**Ministry of Railways
Research, Designs and Standards Organisation
Manak Nagar, Lucknow-226 011**

Modification Sheet No. ELRS/MS/ 0261

1.0 **Title :** Modification in the DBR control circuit to prevent opening of C145 contactor
with snap action in case of :

MODIFIED DBR CONTROL CIRCUIT

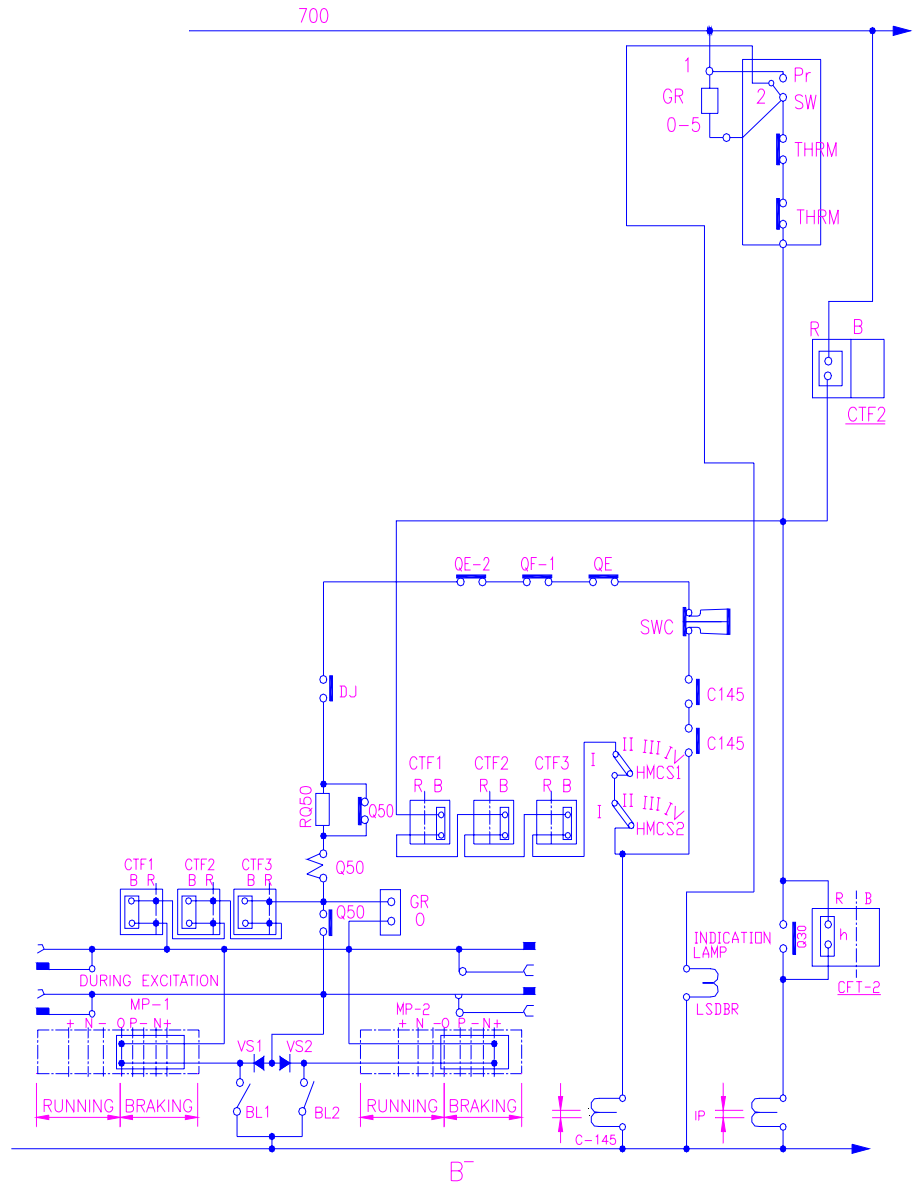
- (i) Energisation of QF1, QF2, QE relays.
- (ii) Energisation of SWC due to application of brakes through SA9 by driver while in Dynamic Braking mode.

- 2.1 To avoid jerk in the locomotive due to sudden opening of C145 contactor while in DBR mode.
- 2.2 To improve driver's confidence level while working in DBR mode on down gradient since due to energisation of QF1, QF2, QE or SWC will not reduce the DBR effort to 'O' instead it will reduce the DBR effort to an appropriate value by causing regression of GR.
- 2.3 To improve reliability of C145 contactor by reducing its maintenance requirements as on load opening will be avoided.

- 3.1 Control circuit to be modified as given in enclosed annexures.
- 3.2 Cable index is to drawn by the implementing agencies themselves for different types of locomotives.
